PLCA improvement for high node count

PLCA improvement for high node count

Presenter: Wojciech Koczwaro, Rockwell Automation

PLCA with big delay line (large number of nodes) - **PROBLEM**

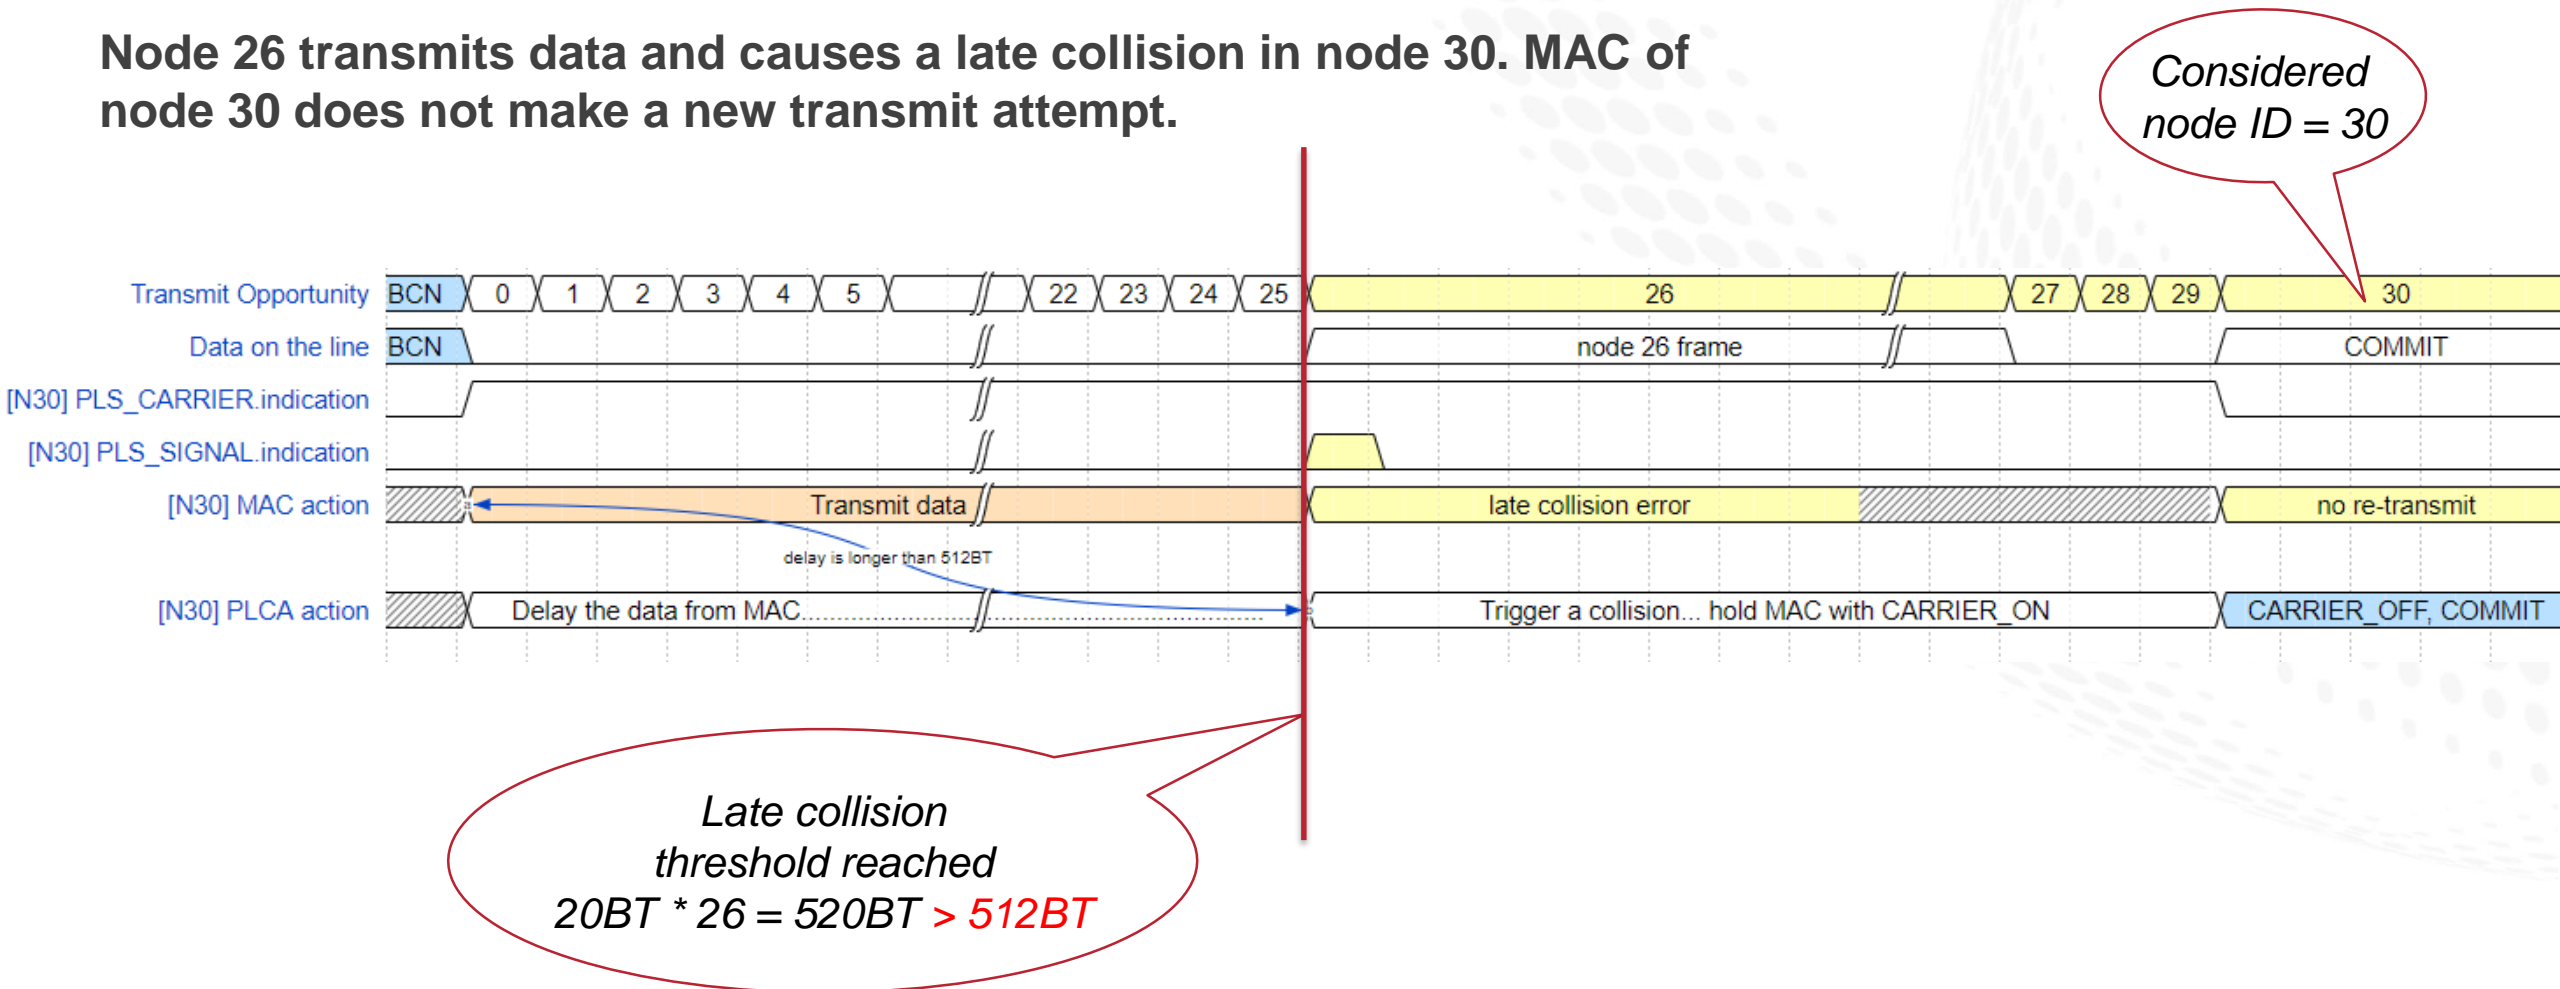
Due to excessive delay, late collision threshold ($\geq 512\text{BT}$) is reached in MAC.

Node 26 transmits data and causes a late collision in node 30. MAC of node 30 does not make a new transmit attempt.

PLCA with big delay line (to_timer = 60BT) – PROBLEM

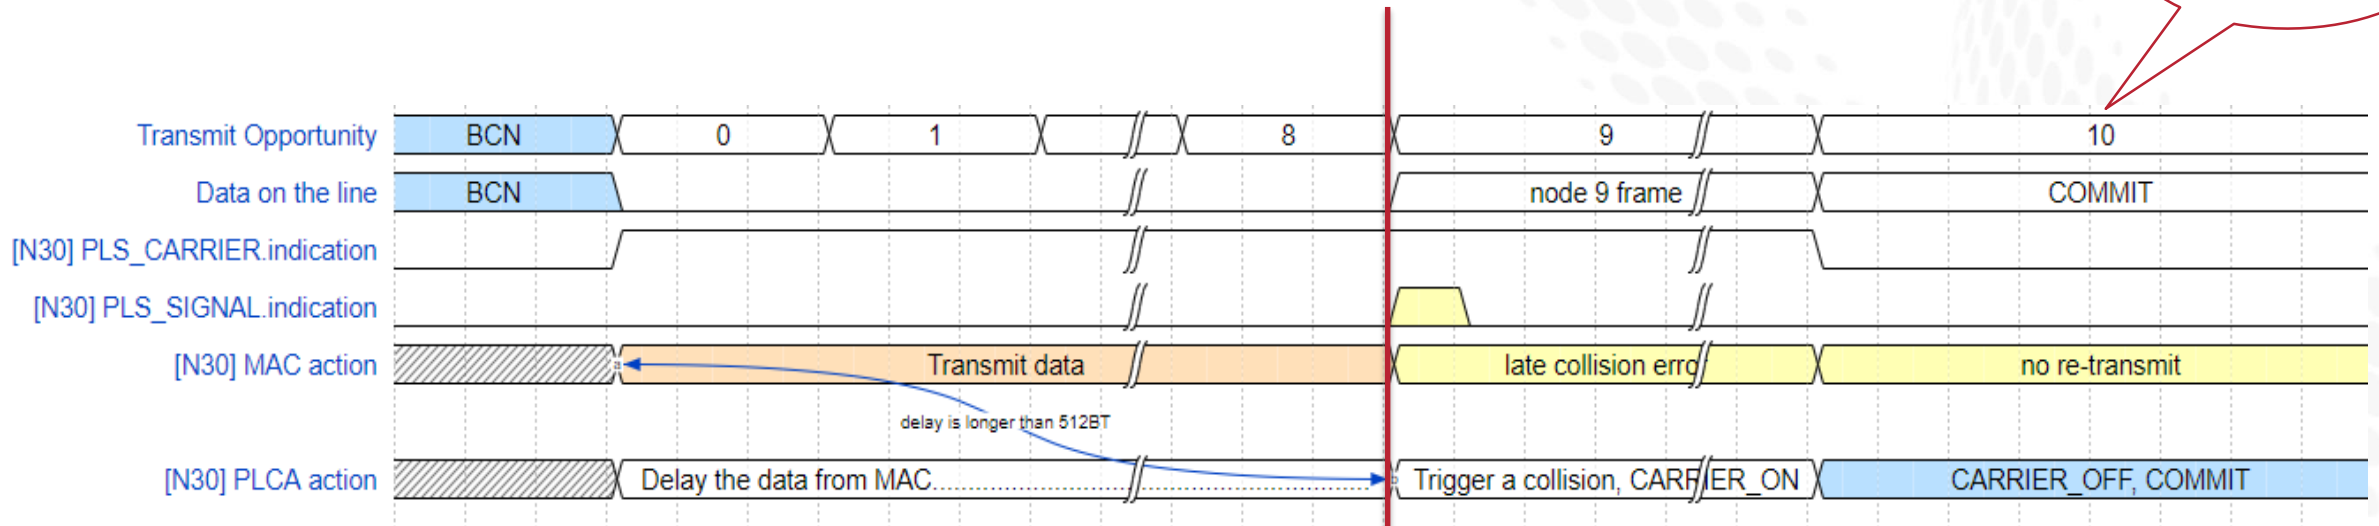
Node 9 transmits data and causes a late collision in node 10. MAC of node 10 does not make a new transmit attempt.

Late collision threshold reached
 $60\text{BT} * 9 = 540\text{BT} > 512\text{BT}$

Figure 148-4—PLCA DATA state diagram

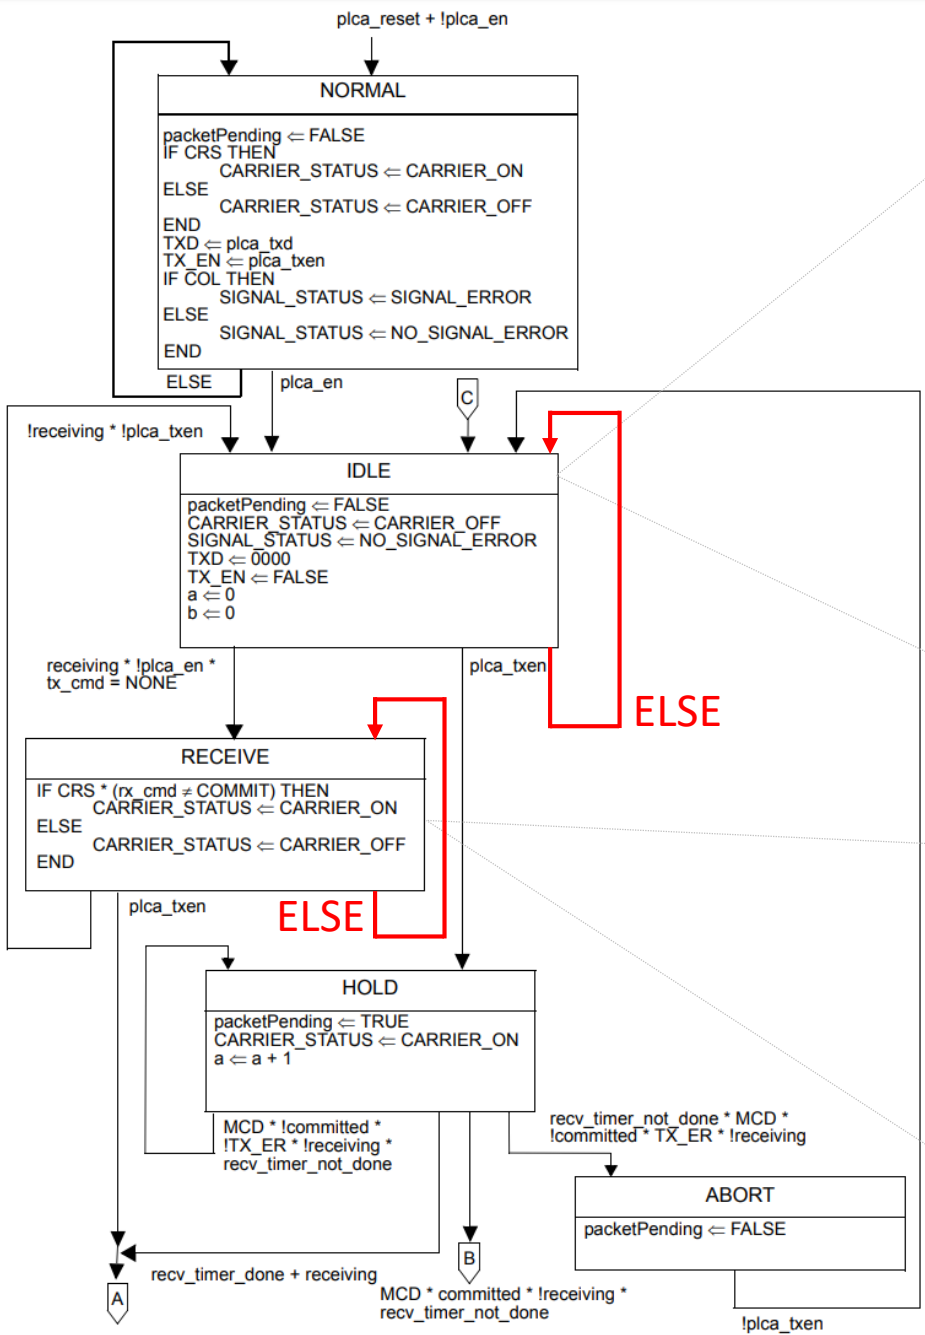
1. change text as indicated in the boxes
2. add recirculating arcs as indicated in red

packetPending <= FALSE
IF CARRIER_INTERDICTED(curID) THEN
  CARRIER_STATUS <= CARRIER_ON
ELSE
  CARRIER_STATUS <= CARRIER_OFF
END
SIGNAL_STATUS <= NO_SIGNAL_ERROR
TXD <= 0000
TX_EN <= FALSE
a <= 0
b <= 0

IF CRS * (rx_cmd ≠ COMMIT) + CARRIER_INTERDICTED(curID) THEN
  CARRIER_STATUS <= CARRIER_ON
ELSE
  CARRIER_STATUS <= CARRIER_OFF
END

Figure 148-2—PLCA functions within the Reconciliation Sublayer (RS)

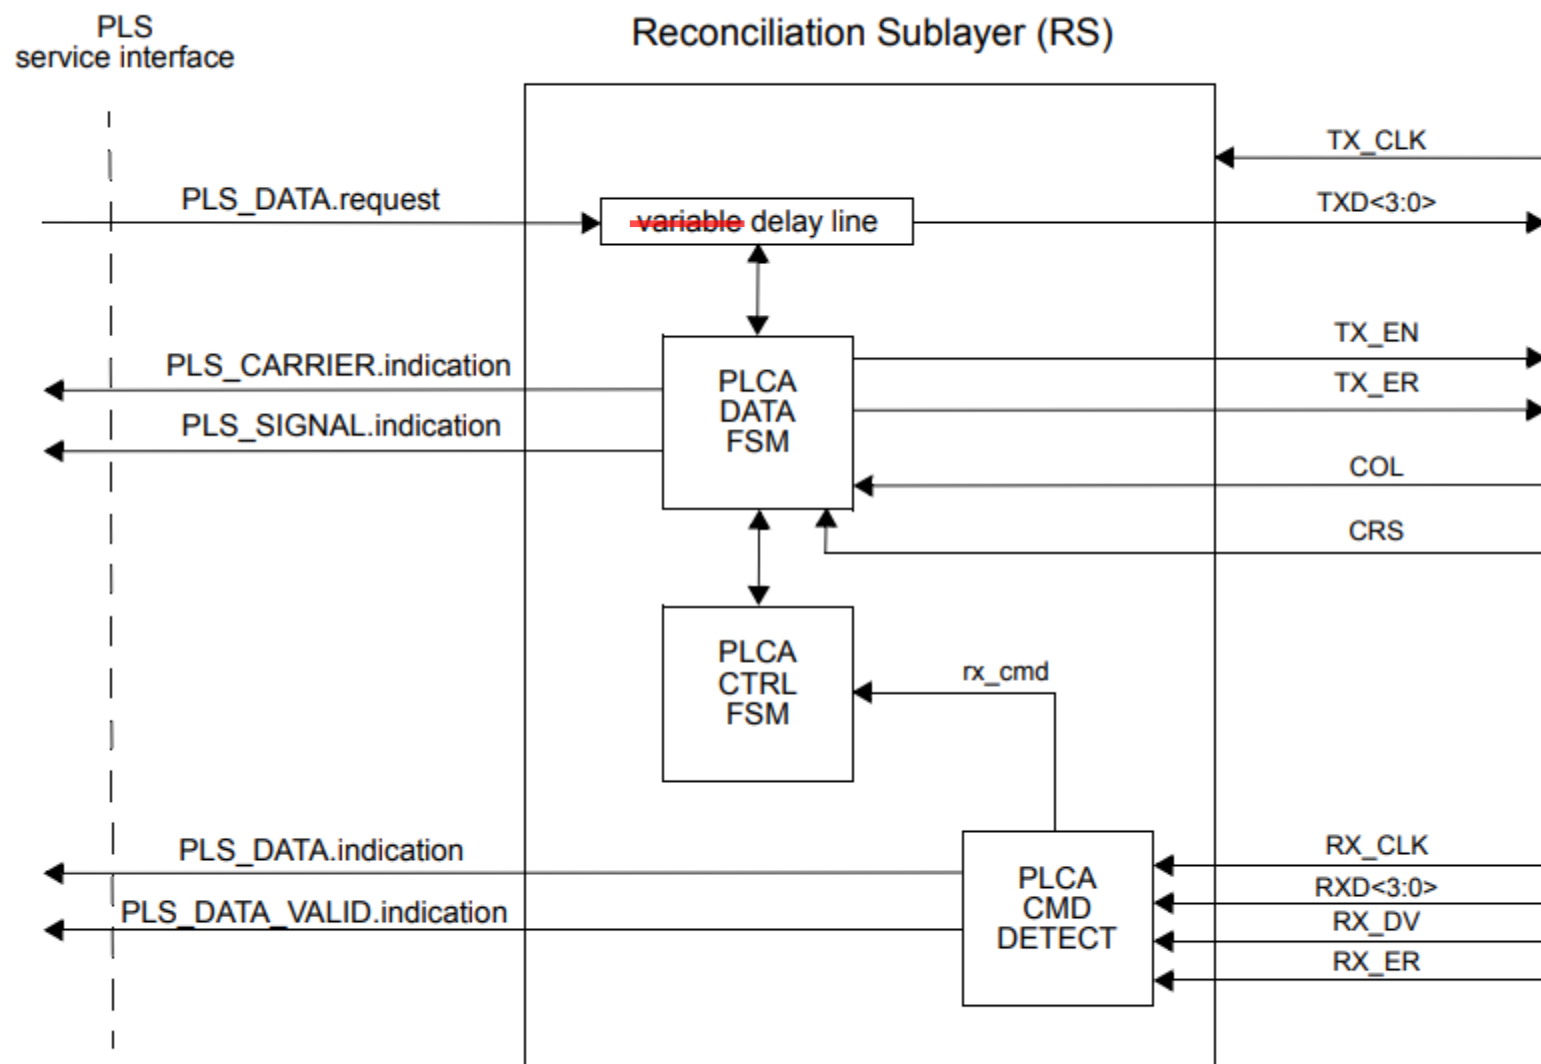
delay_line_length

This constant is implementation dependent and specifies the length of the PLCA RS delay line depicted in figure 148-2.

Value: 276 to 496 bit times
